Attachment A - Detailed response to all agency submissions including DPIE													
Issues Raised by Agency Submissions	Proponent's Response												
Department of Planning Industry and Environment (DPIE)													
General													
<p>The Department wishes to emphasise the importance of consistency and accuracy in terminology and naming throughout all documentation.</p> <p>There are several instances where items are incorrectly named (e.g. Belmont, Belmond, Elmont) throughout the report and figures do not add up (e.g. Table 4 (56+34=90, however the total presented is 88) and these generate confusion.</p> <p>The Department recommends a thorough review be undertaken of all documentation prior to formal lodgement.</p>	<p>It is acknowledged that there are two spelling errors (Belmond Road and Elmont Road) in the spelling of a street name in the EIS. The correct street name is 'Belmont Road'.</p> <p>It is also acknowledged that the calculation of total trees in Table 4 in the EIS is incorrect. The total trees on site under this SSDA should be 90. Note. This does not account for additional one (1) tree to be removed, which has been approved under separate REF approval. Refer

Figure 1 – Proposed Building Set Out Plan

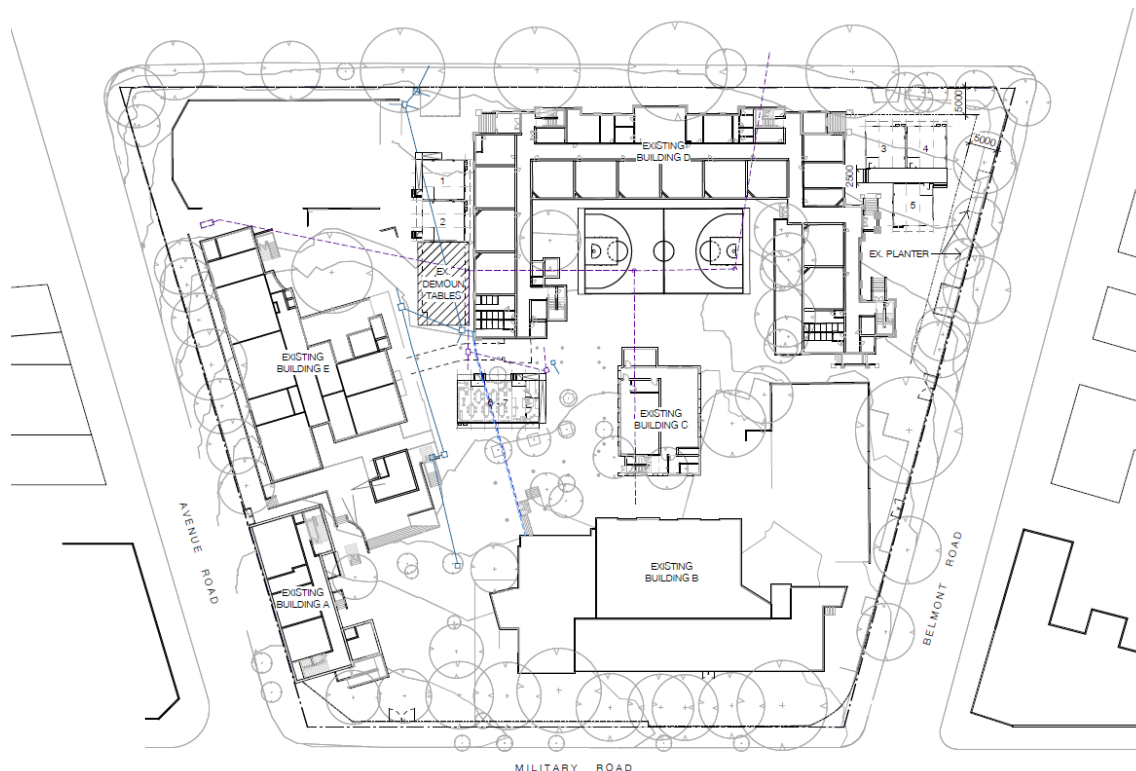
<p>A summary of works approved as part of the REF, particularly in relation to the ongoing use of the school for both school and community purposes.</p>	<p>Early works are sought under a separate REF approval, dated 19 August 2020. A summary of the works sought under the REF is provided below.</p> <p>The proposed activity comprises:</p> <ul style="list-style-type: none"> - Internal refurbishment of Building D (existing classroom building adjoining Gladstone Avenue frontage); - Installation of two (2) temporary portable classrooms (single storey) to Gladstone Avenue frontage; and - Utility services infrastructure and associated removal of one (1) small tree within the site.
<p>Clarification on the number of permanent buildings at the site and the number of demountable buildings (current and anticipated during construction). These should be clearly labelled on a diagram.</p>	<p><u>Permanent Buildings</u> Mosman High School currently contains five (5) permanent buildings on site, referred to Buildings A through to E. Refer to Site Plan below.</p> <p>Demolition of Building B and Building C and part of E is proposed including a two storey roof overhang and separated amenities block and the existing elevated walkway that links Buildings B and C.</p> <p>Buildings A and D will be retained due to their heritage value and significance to the site.</p> <p><u>Demountable buildings</u> Mosman High School currently contains two (2) single storey demountables on site, located on the southern side of Building D.</p> <p>As the school is required to remain operational during construction works, separate early works are being carried out in advance of the main works to install seven (7) temporary single-storey demountables on site, in addition to the existing two (2) single storey demountables including:</p> <ul style="list-style-type: none"> - Retention of two (2) existing single storey demountables, located to the south of Building D; - Installation of two (2) single storey demountables located to the south of Building D (adjacent to the west of existing demountables); and - Installation of five (5) additional single storey demountables (including three (3) located in the north-west corner and two (2) centrally within the site), setback 5m from street boundaries (Gladstone Avenue and Belmont Roads); <p>In total, there will be nine (9) demountables on Site during the construction of the proposed development. Refer to Decant Site Plan, prepared by Woods Bagot at Attachment C, extract of plan also provided below (overleaf).</p>

Installation of seven (7) new single storey demountables in addition to two (2) existing demountables. New demountables identified on plans as “1” through to “7” and existing demountables identified as “DEMOUNT X2”.

Note. New demountables “1” and “2” were approved under separate REF planning pathway. Approval dated 19 August 2020. Demountables “3”, “4”, “5”, “6” and “7” are Exempt Development.

Figure 2 – Façade Palette
Source: Woods Bagot

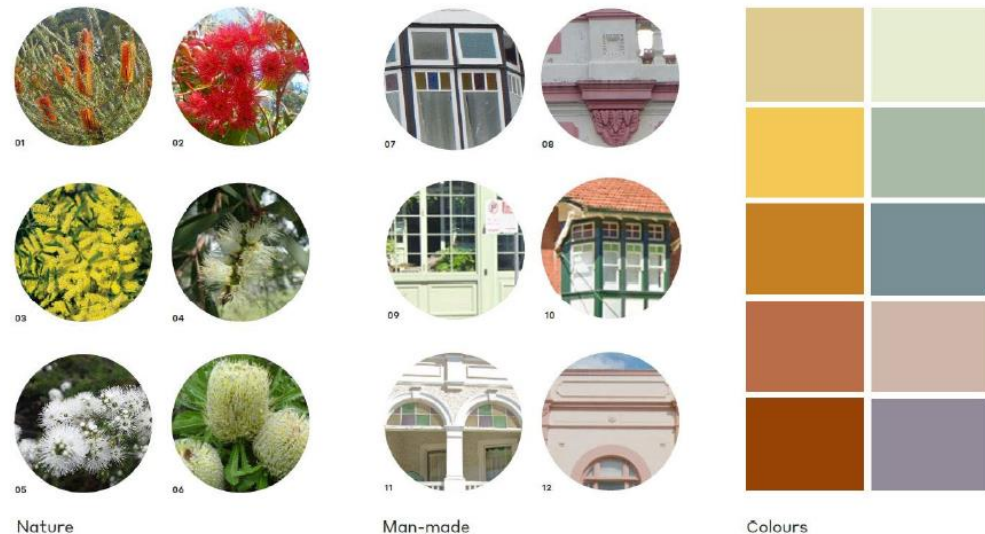
The façade design has responded to the built form recommendations by introducing colour and varied window reveals to express a more playful quality. While the playful quality is commended the irregular treatment and application of colour, window size, height, proportion and reveal treatment lacks an underlying logic and does not relate to the internal program.

It is recommended that the façade composition provide more disciplined approach to the application of the playful façade elements and articulation, to achieve a balance between its playful qualities and civic presence.

Playfulness of the varied window size and colours contribute to the façade articulation along Military Road. The value proposition for the window arrangement was not to relate directly to the room use but for any use now or in the future. The brief requirement was for "flexibility for the future" and the response therefore was to create the building as a vessel for many learning environments. These will change in the future depending on pedagogy shifts and school curriculum requirements.

A clear design logic has been followed for both colour selection and sizing.

*The variety of colour originates from both the natural and built landscape of Mosman. Being located in an area of vibrant native Australian nature and historic buildings, a wide range of colour has been pulled from the context to create a palette for the façade. Refer to image 1 below. (Note. Refer to **Attachment M** for high resolution of façade palette).*

Using the colours from the surrounding context, they have been applied to the window frames in a continuous way that changes hue as it wraps around the building. The experience of the building will vary depending on the location being observed. Further detail has been added by using a gradient to fade out the colour as it climbs up towards the top level of the building.

The colours have been adjusted, muting them further to decrease the intensity while retaining the colour scheme and its playful nature.
